PLANT NAME: OCONEE UNITS 1-3
jcm

Consists of Proposed revision to BAW
10094 transmitted by B&W Ltr. dated Jan. 24,
1977 to Mr. S. A. Varga, superseded the earlier
revision....

Reference: Oconee Nuclear Station
Docket Nos. 50-269, -270, -287

2. THETA Code Modification

FIGURE 1 HEAT TRANSFER MODES

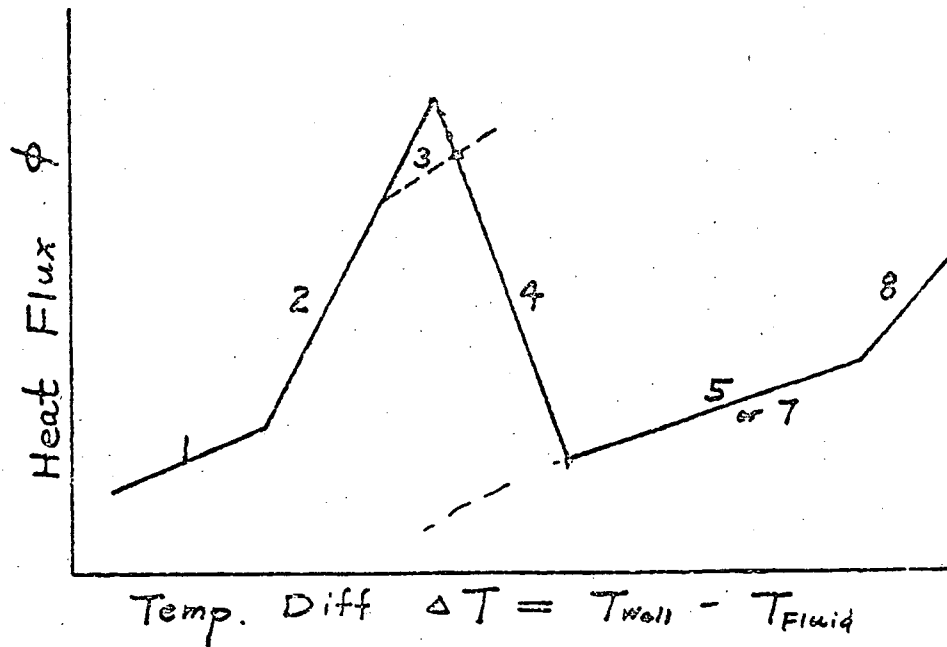
If the trial heat flux was less than CHF, the trial value was taken as the local heat flux. If the trial value exceeded CHF, transition boiling (mode 4) heat flux was used. To correct this, the post-CHF switching logic was modified so that, subsequent to CHF at a particular axial node, regression on the transition boiling curve is restricted to heat fluxes (1) less than CHF for local fluid void fractions less than 80 percent, (2) less than the heat flux calculated by interpolation between nucleate boiling (mode 2) and forced convection vaporization (mode 3) for local void fractions between 80 percent

and 90 percent, or (3) less than the heat flux calculated by forced convection vaporization (mode 3) for local void fractions greater than 90 percent. That is, transition boiling heat fluxes are restricted to values less than those calculated using pre-CHF correlations appropriate to local fluid conditions.

In the event that the local transition boiling (mode 4) heat flux is calculated to exceed the heat flux calculated using pre-CHF correlations according to local fluid conditions, the local heat flux is determined by switching to film boiling (modes 5 and 7). Thus, with this modification, the return to nucleate boiling is replaced by a temporary switch to film boiling.
